Addendum 2

TENDER ADDENDUM NO. 1

Norwood Park Elementary School Accessibility Project
Hamilton Wentworth District School Board RFT-2026-119-P02267

Drawings Issued for Tender, 2026.04.10: (Architectural)

7 DOOR SCHEDULE
A0.2 1:50

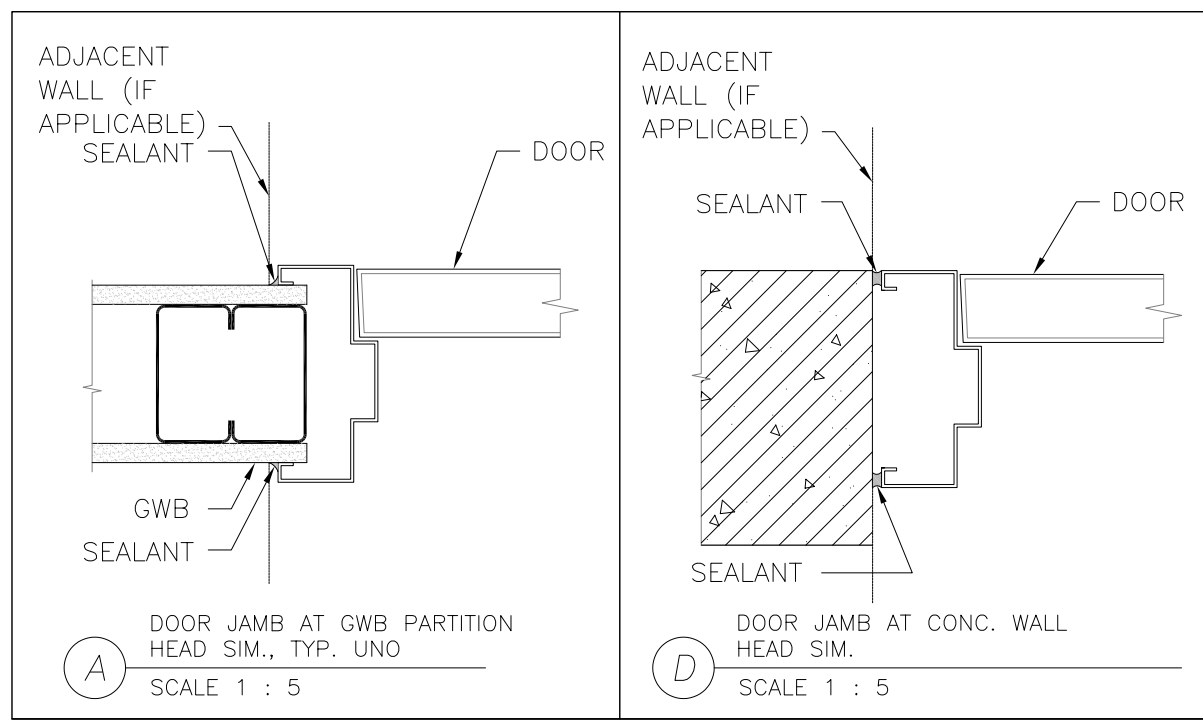
1. ADD Door D136B to 7/A0.2 Door Schedule – see attached 1 page.
2. ADD Interior Partition Type P4 to 8/A0.2 Wall Assembly schedule – see attached 1 page.

6 INTERIOR ELEVATION- CLASSROOM 203
A2.0 1:50

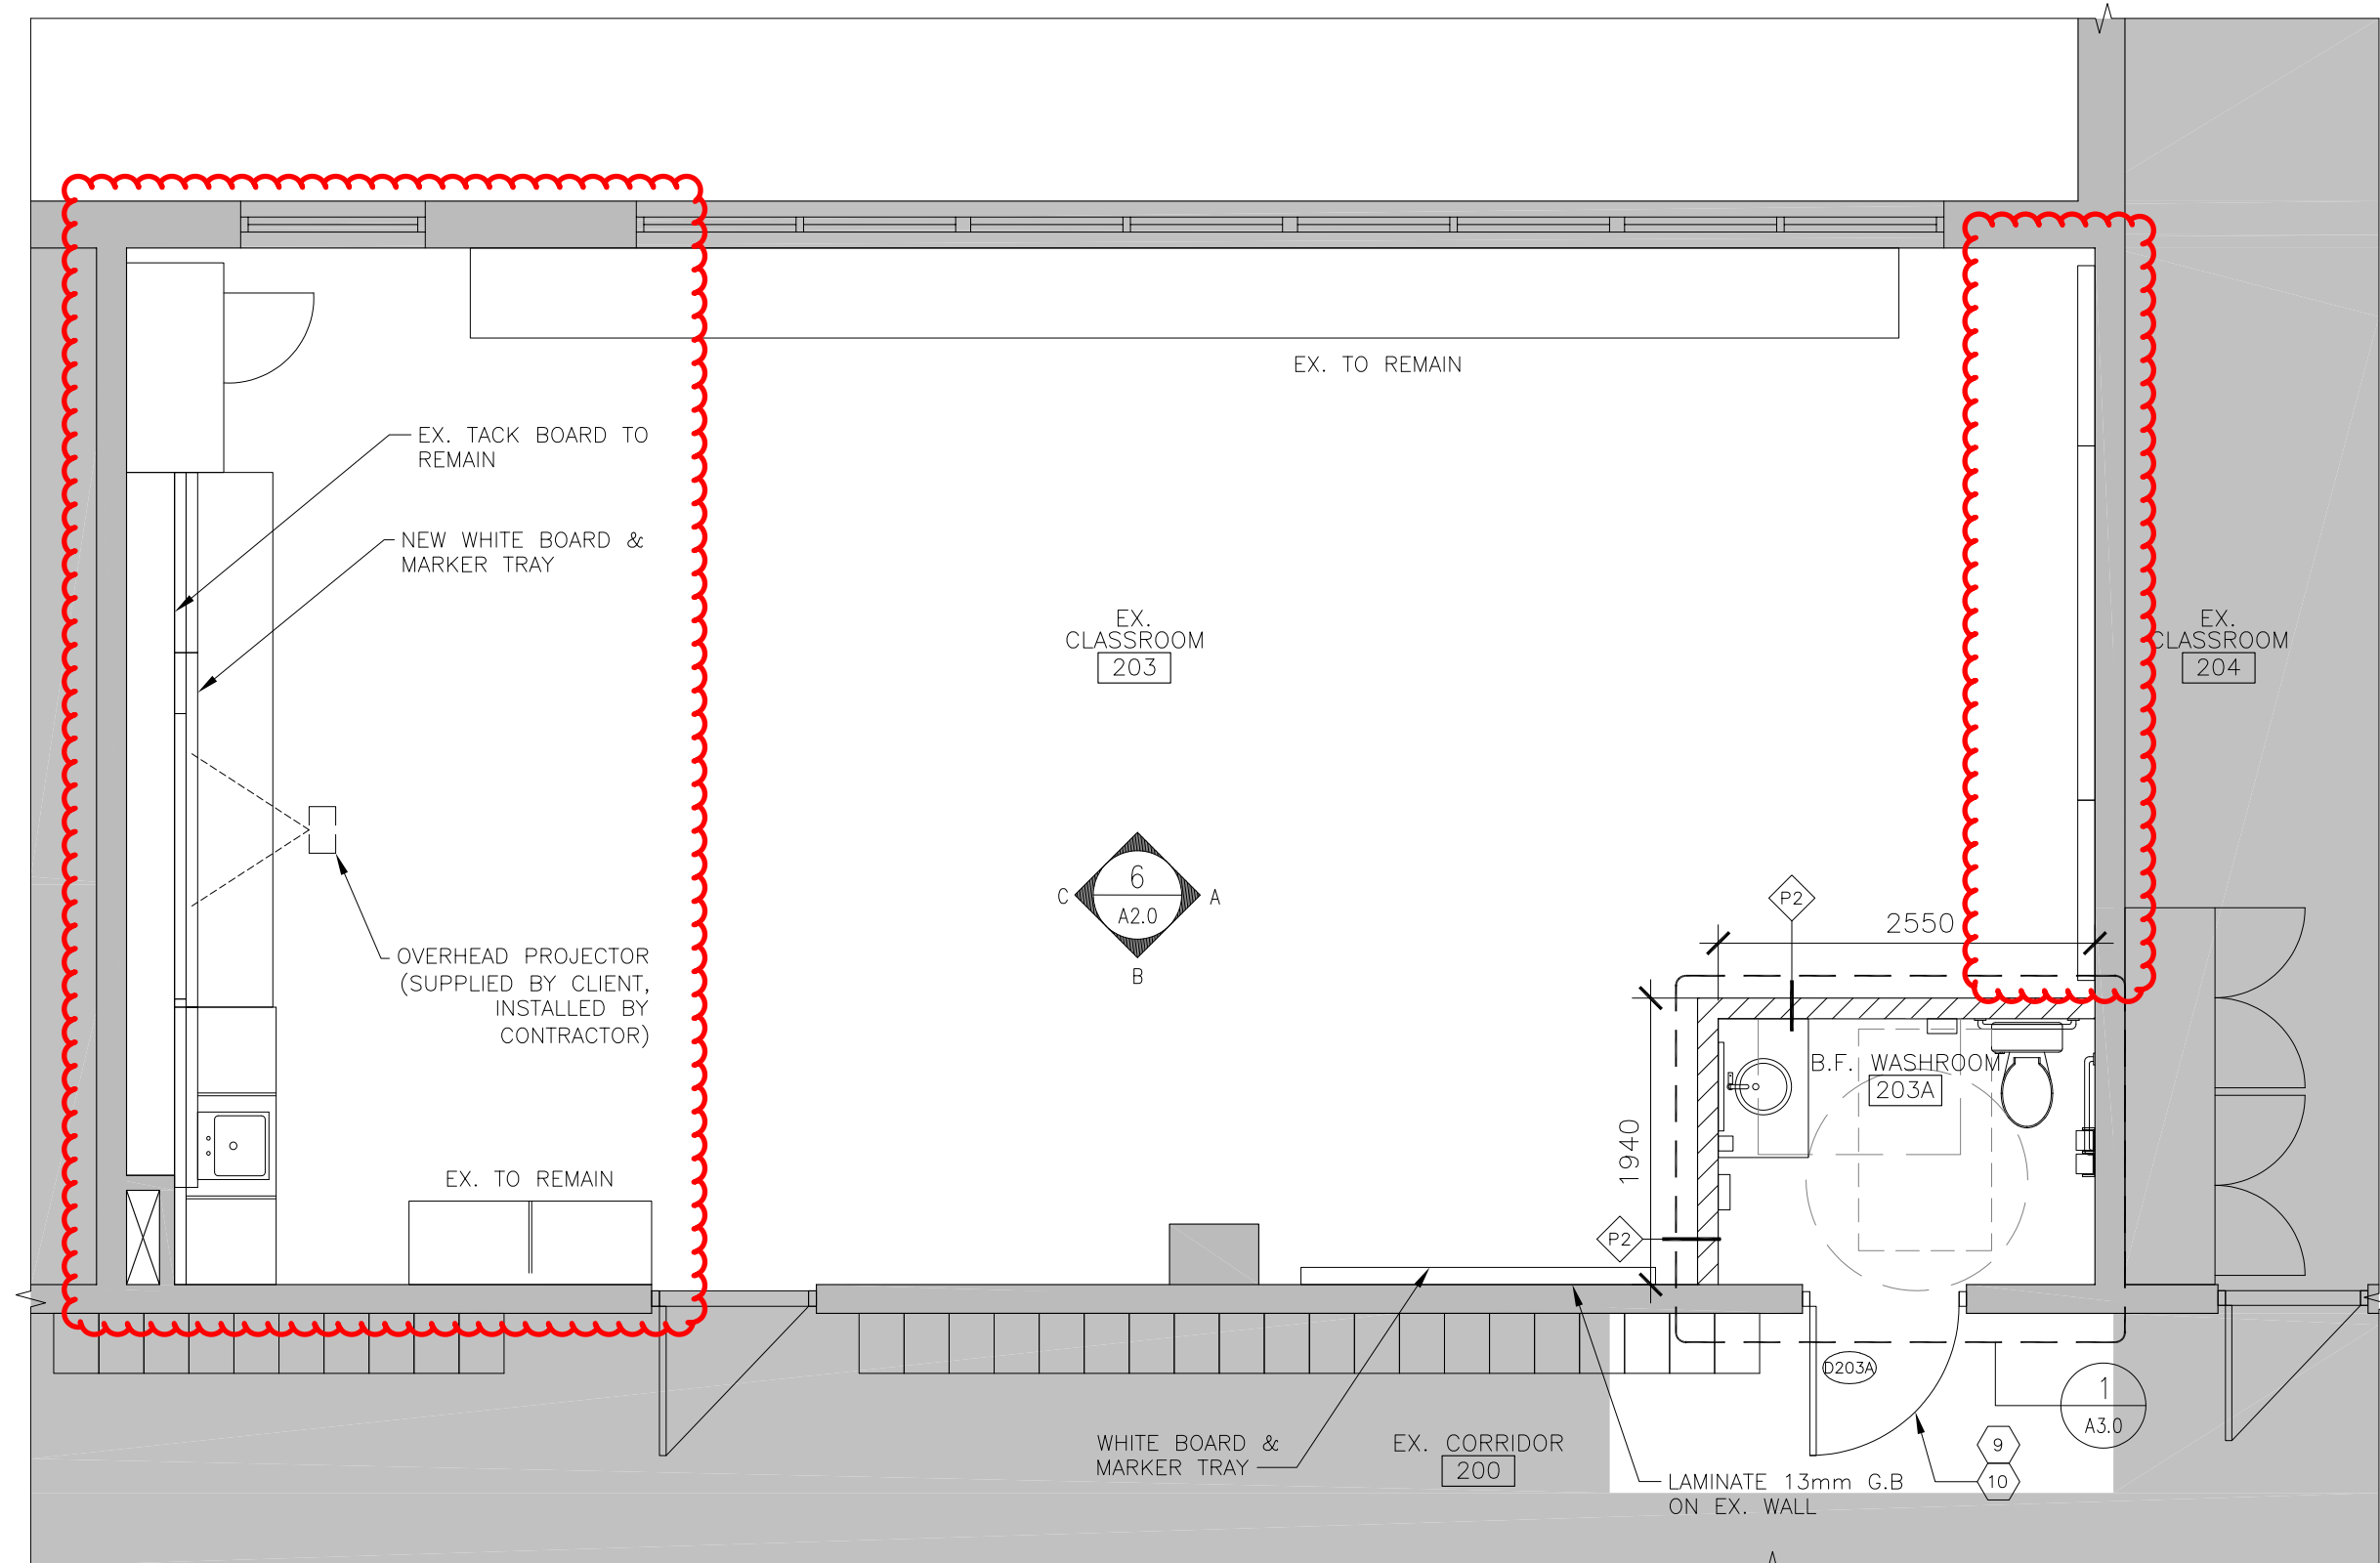
1. REVISE Plan Key Note 7 to be: Install wall ceramic tile (CT-B). Top of tiled area to be 2440 AFF. CT-B tile to extend above elevator door openings.
2. REVISE location of new teaching wall in Ex. Classroom 203 from east wall to west wall. See attached revised drawing A2.0 with bubbled revisions.
